Service Action: Check and Repair the NVLD Wiring Harness

F83 (M4 Convertible)

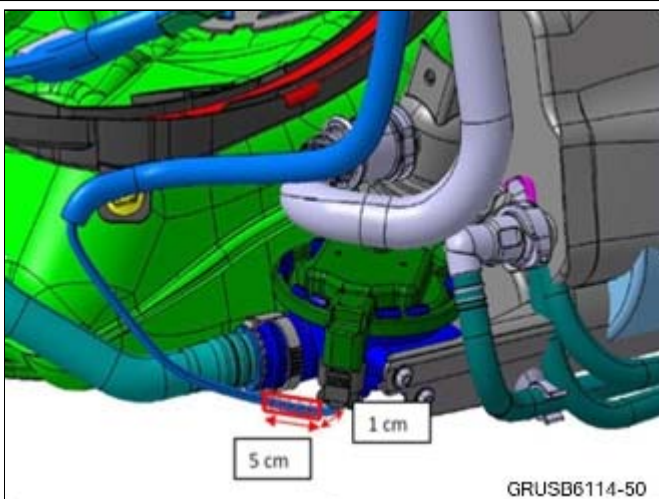
The wiring harness for the NVLD2 (Natural Vacuum Leak Detection: tank leak diagnosis) may rest against the right rear strengthening brace and chafe through the harness insulation. This may lead to a short circuit and blow Fuse 104.

5. Check the wiring for damage in the area of the brace, as shown.
6. If the wiring is damaged, repair as needed based on ISTA Repair Instruction 61 13... "Treating cables and optical fibres," (recommendations for repairing cables).
7. Ensure that Fuse 104 is not blown and replace as needed.

8. Install 5 cm of corrugated tubing around the wiring harness, approximately 1 cm from the connector on the NVLD, as shown. Secure with the fabric adhesive tape.

Check and repair the harness as needed and install corrugated tubing.
